Planning Commission Meeting

4.I. 3309-3345 Dogwood Drive Preliminary Plat Review

4.II. 3309-3345 Dogwood Drive Site Plan Review

As requested, I have reviewed the preliminary plat for the 3335 Dogwood Drive multi-family site to be located on a total of 2.98 acres on the west side of Dogwood Drive, within a U-V and V Zoning District. This review is for compliance with the preliminary plat requirements of Chapter 90 of the City ordinances. The re-submittal was received on August 10, 2022. The plans were prepared by Lowery & Associates Land Surveying, LLC, under the Land Surveyor seal of Mitchell Lowery. With reference to my letter dated July 28, 2022, my comments are as follows:

GSWCC NO. 0000077807
DRAWN BY TGB
DESIGNED BY TGB
REVIEWED BY IDK
DATE 08/09/2022
PROJECT NO. 019955008
TITLE
SITE PLAN
SHEET NUMBER
C2.00

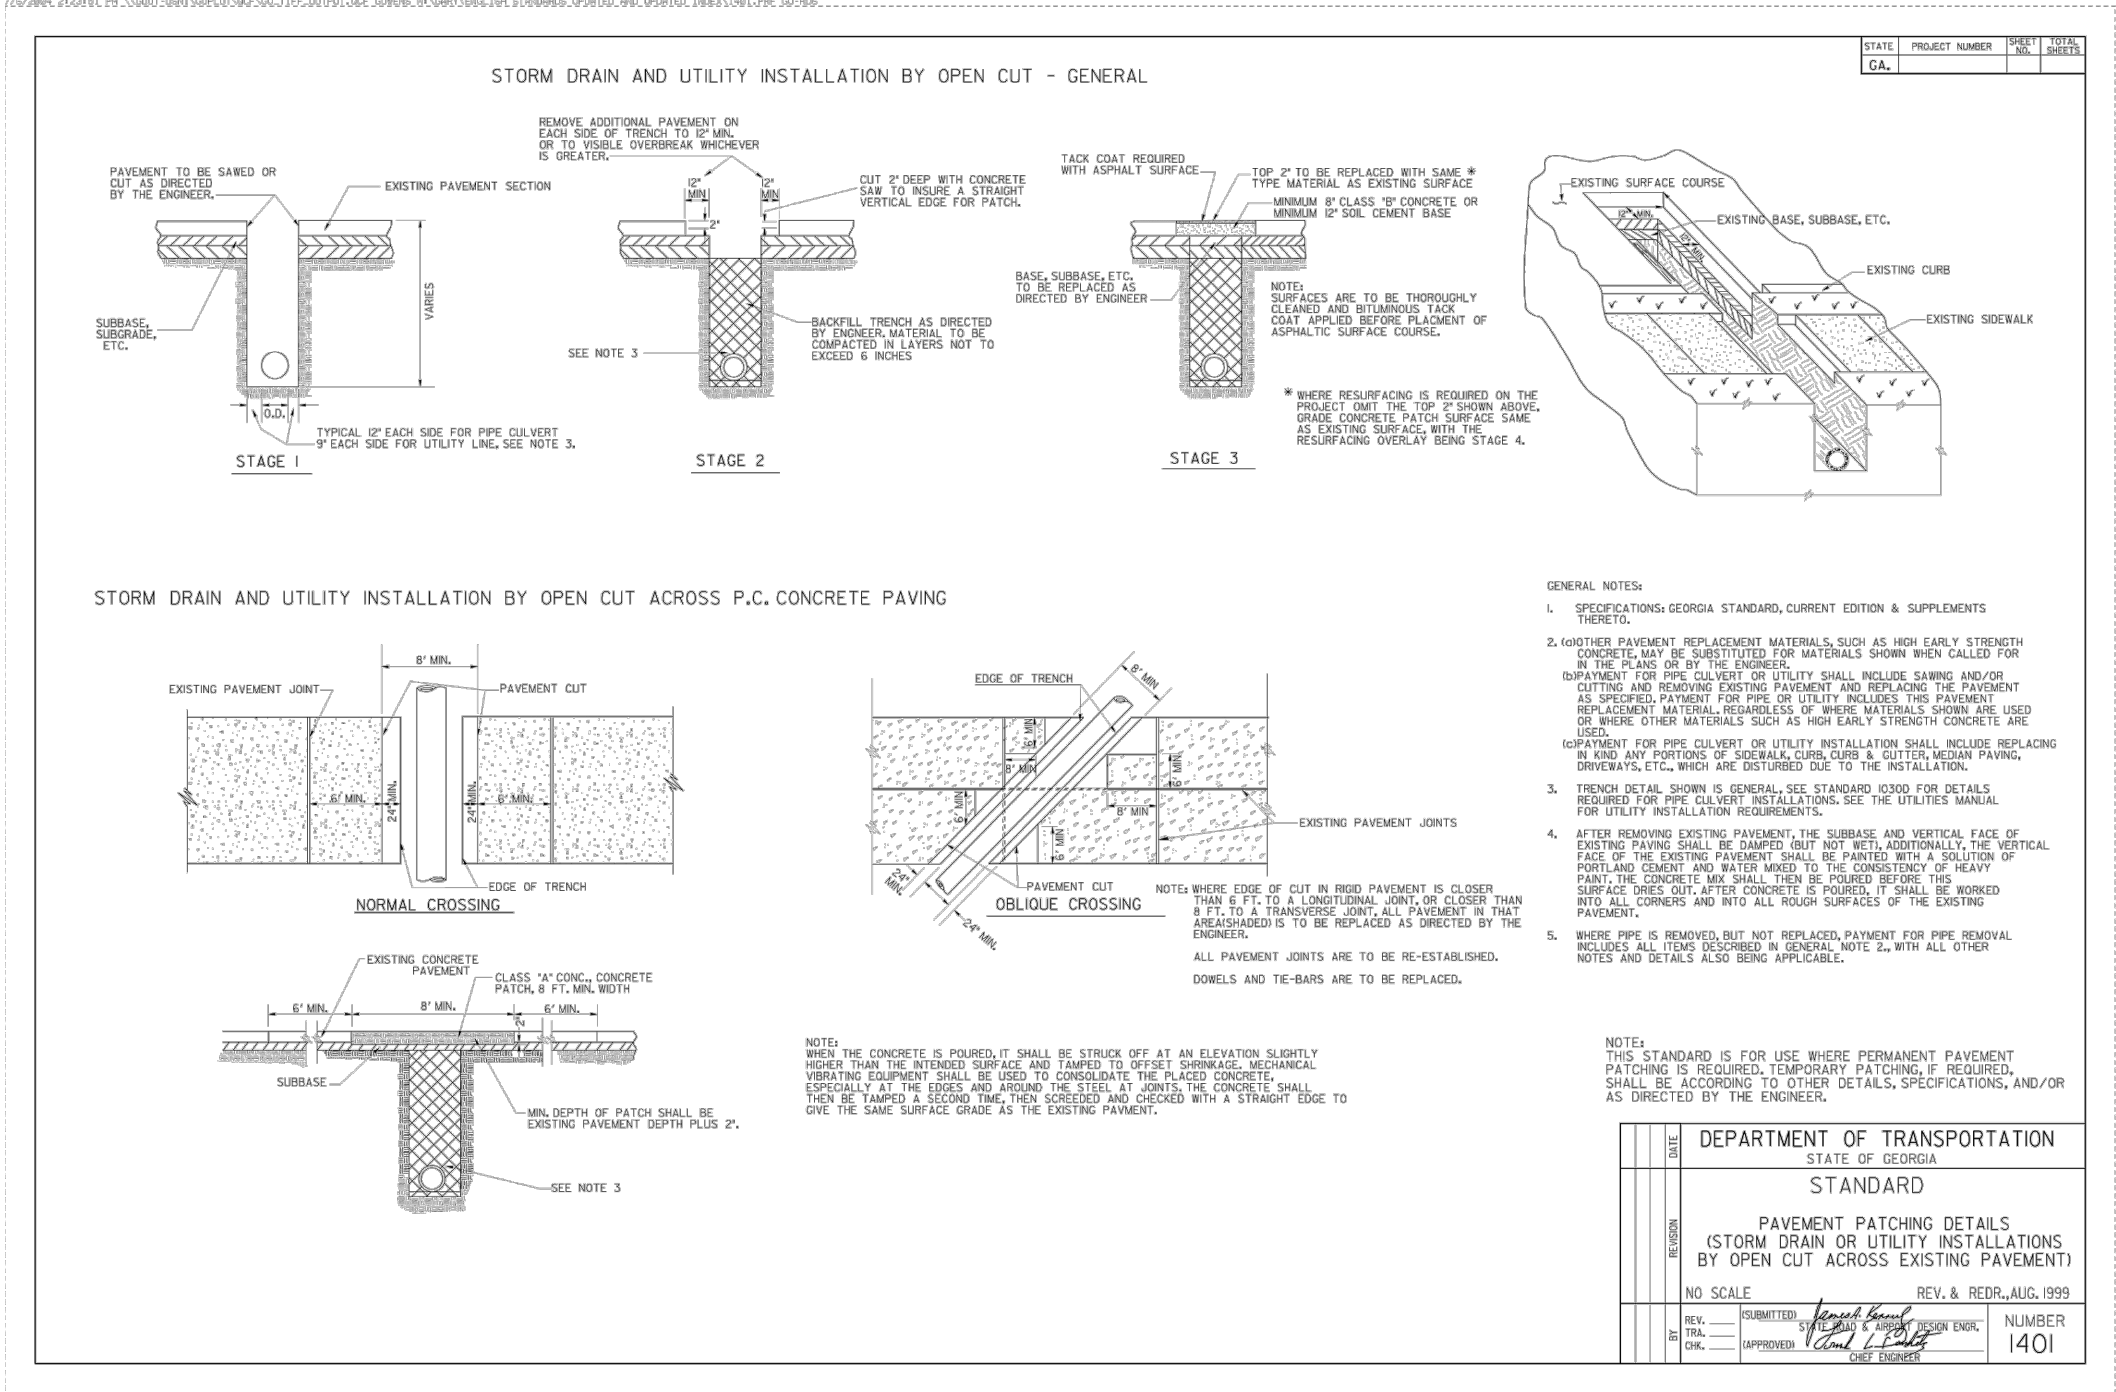
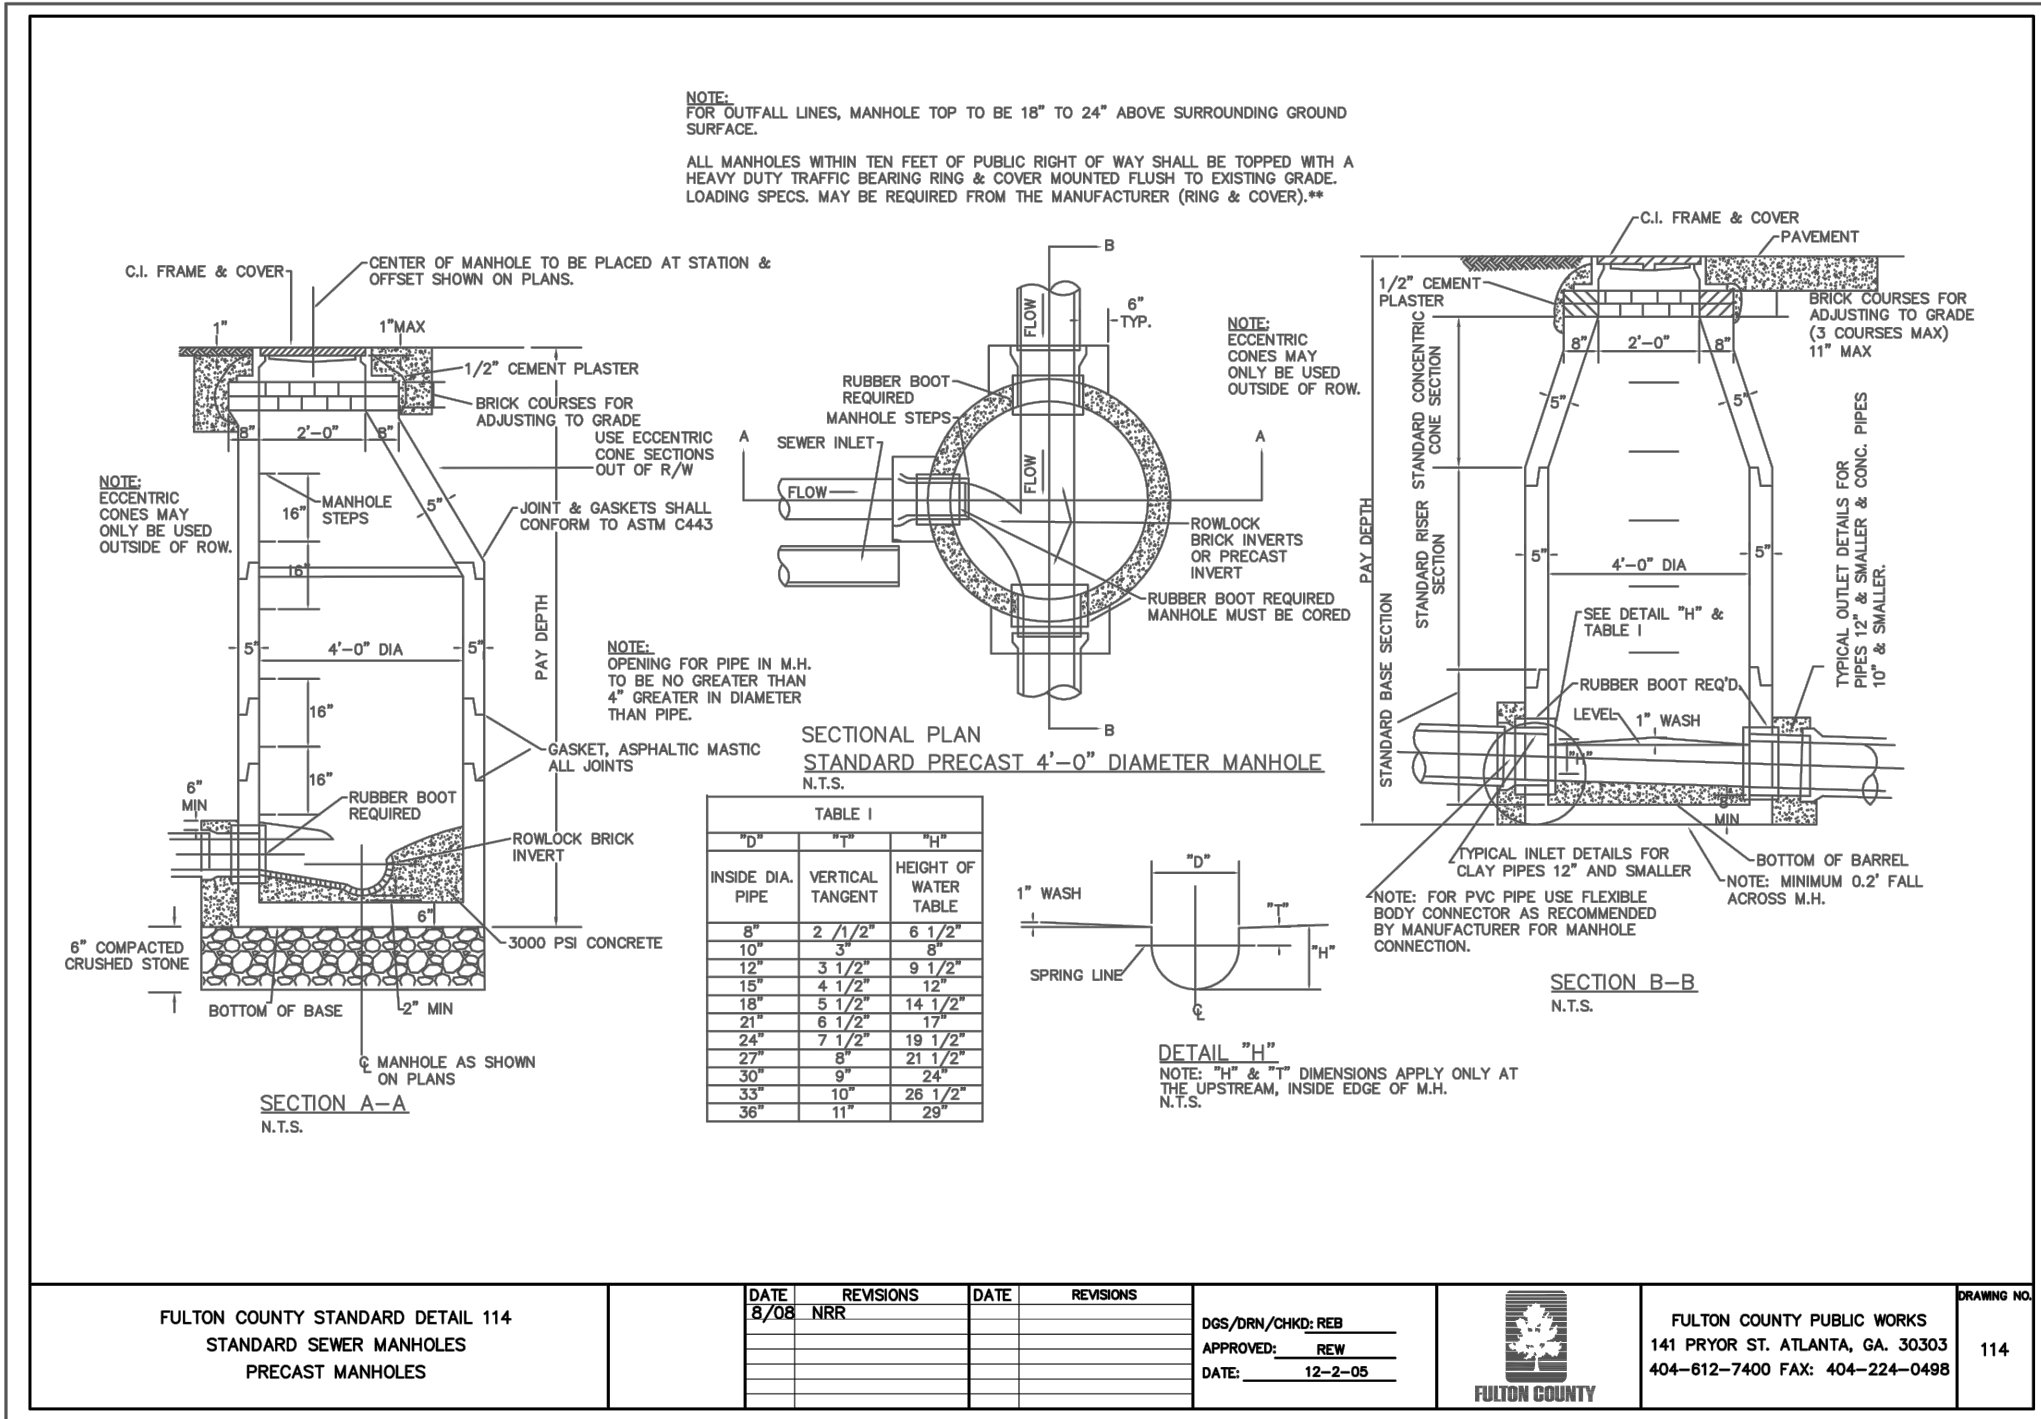
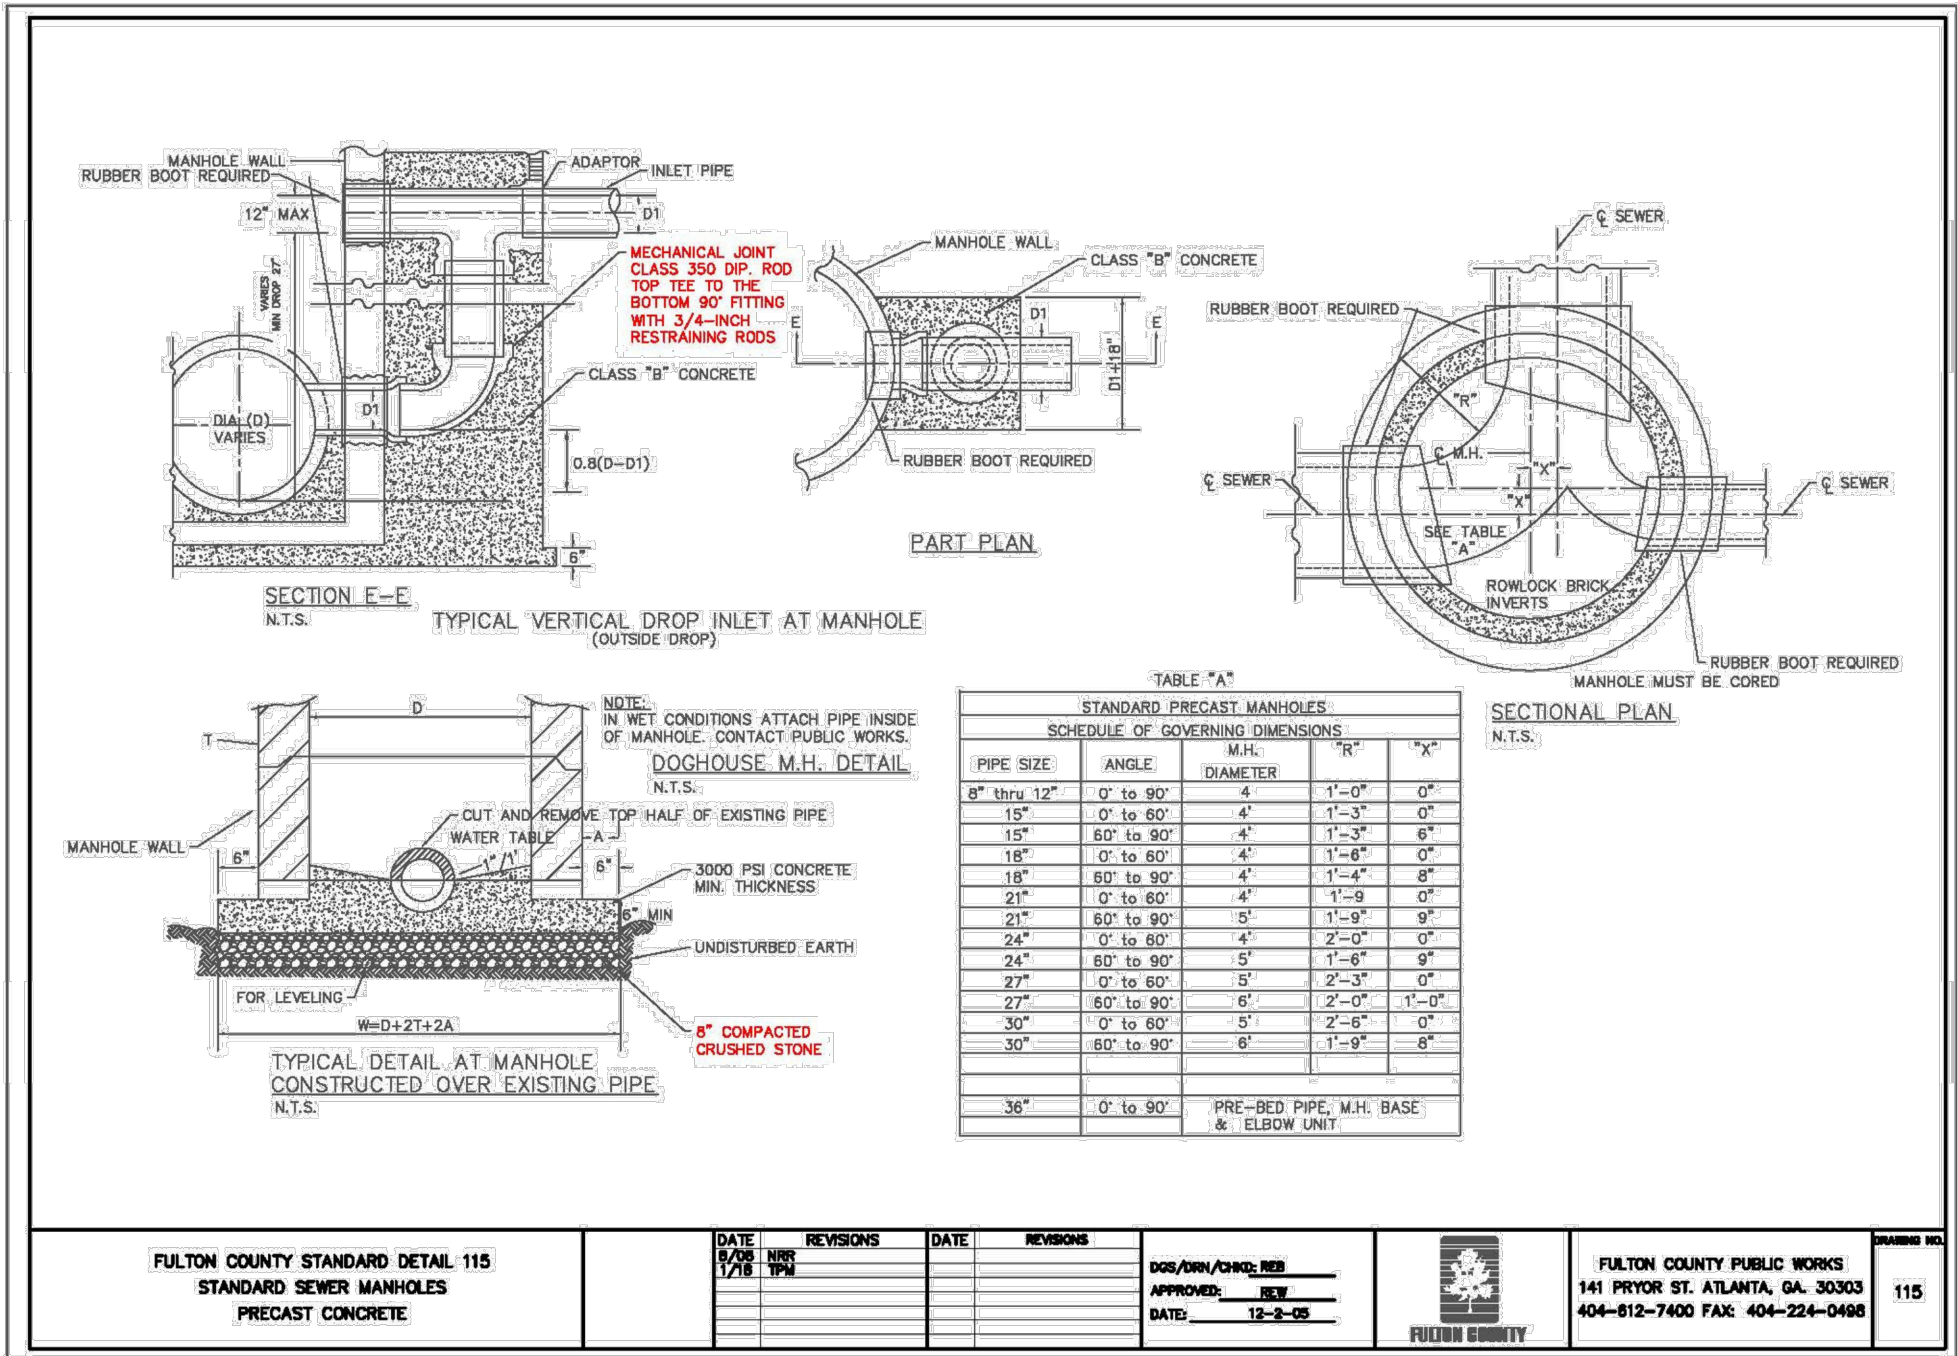
1. Comment addressed by the re-submittal.
2. Comment considered addressed with the statement on sheet C2.00 that pavement section will be determined after receipt of a site geotechnical report.

5. Comment addressed by the re-submittal.
6. Comment not addressed and remains. The current zoning of UV shown on sheet C2-00 does not agree with information shown on the preliminary plat. It appears a portion of the tract may need to go through the City's rezoning process.

13. Comment can be considered addressed if the project narrative on sheet C0.00 and the development summary on sheet C2.00 is sufficient for the City.
14. Comment can be considered addressed if the new storm drain piping routing is addressed in the detailed plans submitted for LDA permitting.
15. Comment can be considered addressed if the remaining issues on the arborist report and final landmark tree data is addressed in the detailed plans submitted for LDA permitting.
16. Comment can be addressed in the detailed plans submitted for LDA permitting.
17. While this submittal review is for concept site plan approval only, the applicant should be aware that submittal and review of detailed site construction drawings will still be necessary prior to land development permitting.
